**TB No. AA-15029**

**SUBJECT:** 212/412/412EP BHVM Upgrade

**DESCRIPTION:** This Technical Bulletin is being issued to allow the owner to upgrade their BHVM kit to:  
Part 1: the current software configuration setup version:  
V4.1 SP4A - V44 – (for non FastFin 212, 412, 412EP)  
V4.1 SP4A - V45 - (for 212, 412, 412EP w/FastFin installed)  
Part 2: remove the disconnect on the Tail Rotor Bracket Assembly to eliminate corrosion.  
Part 3: relocate the upper mast accelerometer for more accurate data collection (FOR 412, 412EP ONLY).

**FIGURE 6 – BACKSHELL AND CONNECTOR INSTALLATION**  
(BALLOON NUMBERS CORRESPOND WITH APPROPRIATE INSTRUCTION STEP)

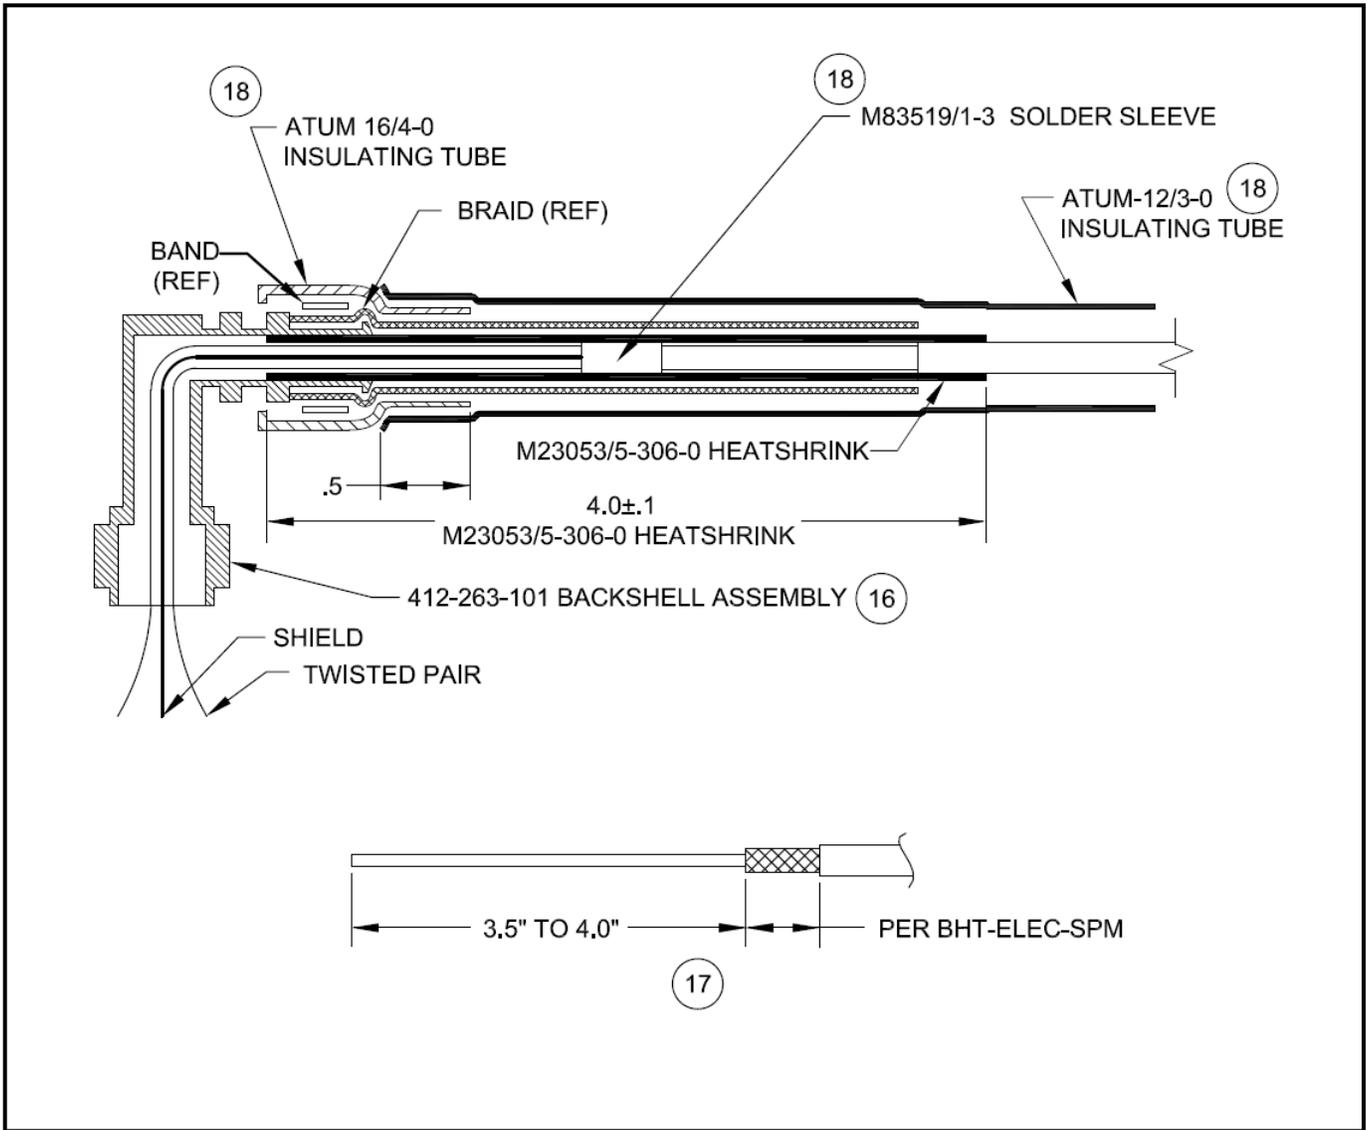
17. Prepare ends of wires HVM24A22 and HVM26A22 as shown in Figure 6.
18. Install Connector (D38999/20WA35SA) using Solder Sleeves (M83519/1-3), Sockets (M39029/56-348, Heatshrink (M23053/5-306-0), Insulated Tubing (ATUM-16/4-0), and Heatshrink (ATUM-12/3-0), as shown in Figure 6. Use 6 inch lengths (maximum) of supplied Wire-1 cond unshielded, 22AWG (M22759/41-22-9) for jumper wires - ref Figure's 5 & 6.
19. Orient and install Connector (D38999/20WA35SA) to T/R Bracket Assembly (412-260-103 / 412-260-119) using retained Mounting Flange (M85049/95-10A), Washers (NAS1149DN416J) and Screws (MS35206-216) and as shown in Figure 3. Torque to 6-8 in-lbs.

**FIGURE 7 – EXISTING LOCATION FOR UPPER MAST ACCELEROMER  
(BALLOON NUMBERS CORRESPOND WITH APPROPRIATE INSTRUCTION STEP)**

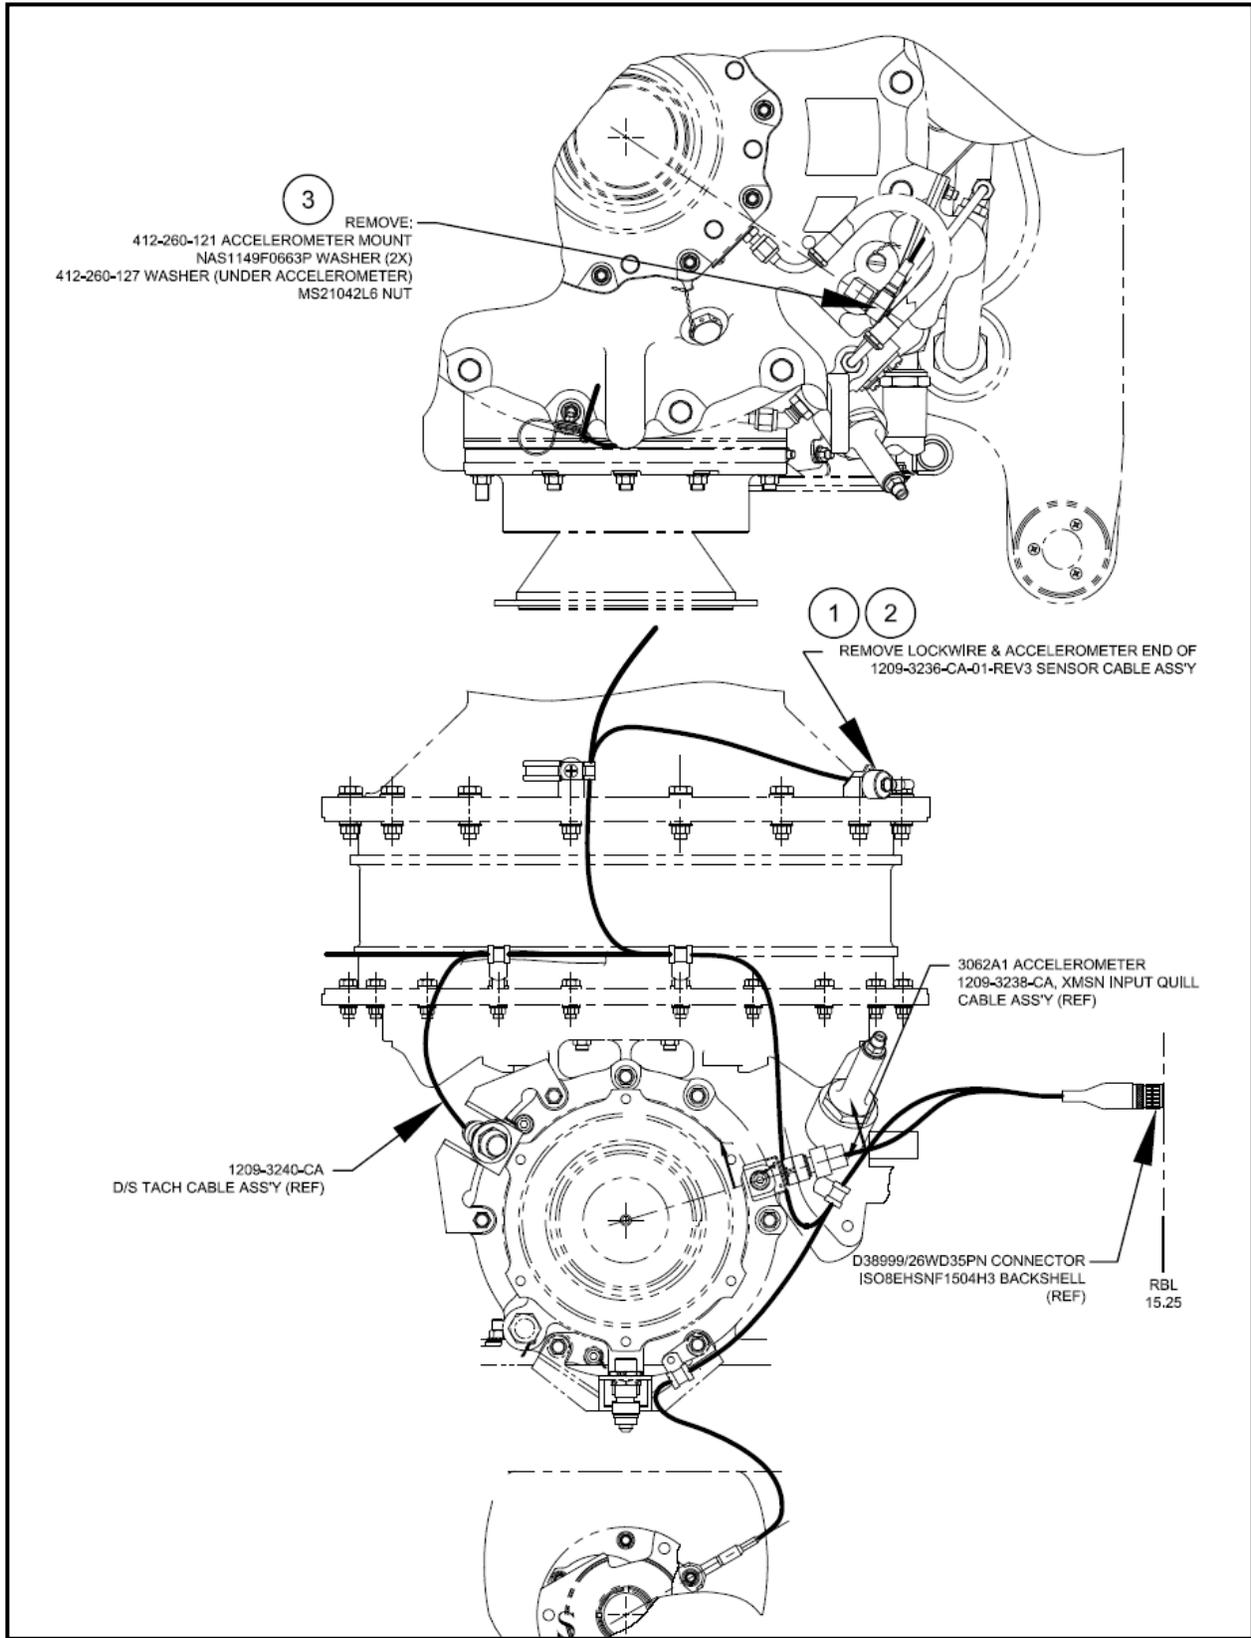
1. Locate mounting location of Transmission Upper Mast Accelerometer – Ref Figure 7.
2. Remove lockwire securing accelerometer end of Sensor Cable Assembly (1209-3236-CA-01-REV3) to Accelerometer Mount (412-260-121), as shown in Figure 7. Loosen captive Bolt to remove sensor cable assembly accelerometer from Accelerometer Mount.

3. Remove Nut (MS21042L6), Washers (NAS1149F0663P), and Washer (412-260-127) to remove Accelerometer Mount (412-260-121) – as shown in Figure 7. Discard hardware and bracket.

**FIGURE 8 – NEW LOCATION FOR UPPER MAST ACCELEROMETER (BALLOON NUMBERS CORRESPOND WITH APPROPRIATE INSTRUCTION STEP)**

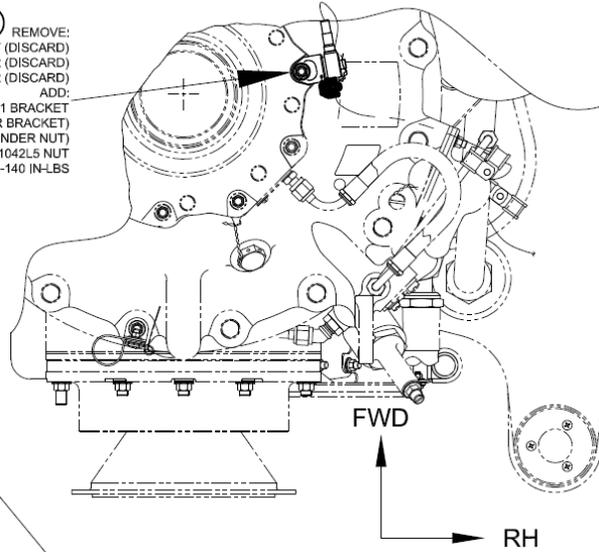
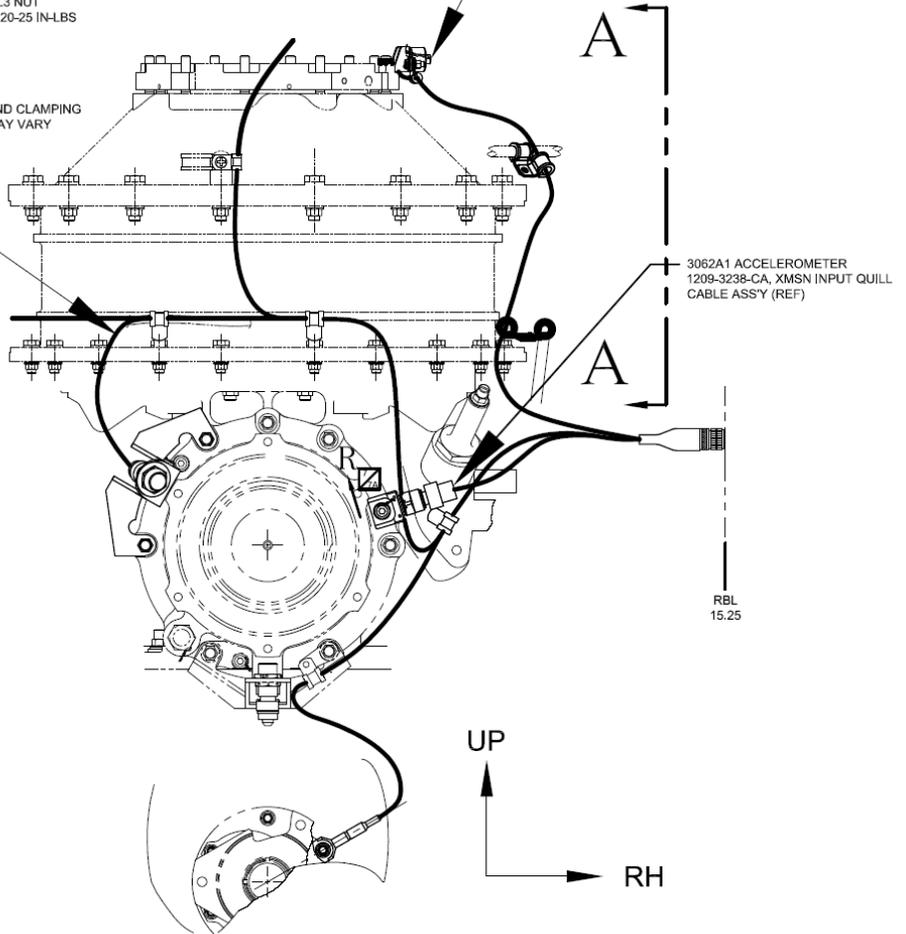
4. Locate new mounting location for Transmission Upper Mast Accelerometer, as shown in Figure 8.
5. At the new mounting location, remove Nut (MS21042L5), Washer (NAS1149F0532P) and Washer (NAS1149D0563J), as shown in Figure 8. Discard hardware.

6. Un-clamp Sensor Cable Assembly (1209-3236-CA-01-REV3) from nearby clamps, as required, to enable routing of the accelerometer to the new mounting location, as shown in Figure 8.

7. Apply Sealant (870 B-2) between Accelerometer Bracket (412-365-121) and Mast Bearing Retaining Plate to fill gap. Install Accelerometer Bracket, using Washer (NAS1149D0532J – under bracket), Washer (NAS1149F0532P – under nut) and Nut (MS21042L5) – ref Figure 8. Orient bracket such that accelerometer centerline passes through centerline of transmission housing. Torque nut to 100-140 in-lbs.
8. When installing accelerometer, ensure that arrow on accelerometer points away from aircraft. Install accelerometer end of Sensor Cable Assembly (1209-3236-CA-01-REV3) to accelerometer bracket using accelerometer

captive screw. Torque accelerometer attaching bolt to 20-25 in-lbs and secure with Lockwire per NASM33540 – ref Figure 8.

9. Install Clamp (MS21919WDG2) using Screw (NAS1801-3-9), Washer (NAS1149D0332J) and Nut (MS21042L3), as shown in Figure 8. Torque to 20-25 in-lbs.
10. Clamp remainder of Sensor Cable Assembly as required to ensure that cable does not contact moving parts.
11. Mark/label wires per AC43.13-1.
12. Reference appropriate ICA report and perform an accelerometer check of the modified components.
13. Relocation of upper mast accelerometer complete.

- 5 REMOVE:  
MS21042L5 NUT (DISCARD)  
NAS1149F0532P WASHER (DISCARD)  
NAS1149D0563J WASHER (DISCARD)  
ADD:  
412-365-121 BRACKET  
NAS1149D0532J WASHER (UNDER BRACKET)  
NAS1149F0532P WASHER (UNDER NUT)  
MS21042L5 NUT  
TORQUE 100-140 IN-LBS

- 9 MS21919WDG2 CLAMP  
NAS1801-3-9 SCREW  
NAS1149D0332J WASHER  
MS21042L3 NUT  
TORQUE 20-25 IN-LBS

- 8 1209-3236-CA-O1-REV3 SENSOR CABLE ASSY  
TORQUE 20-25 IN-LBS  
LOCKWIRE PER NASM33540

- 7 **DETAIL INSTALLATION OF 412-365-121 BRACKET**
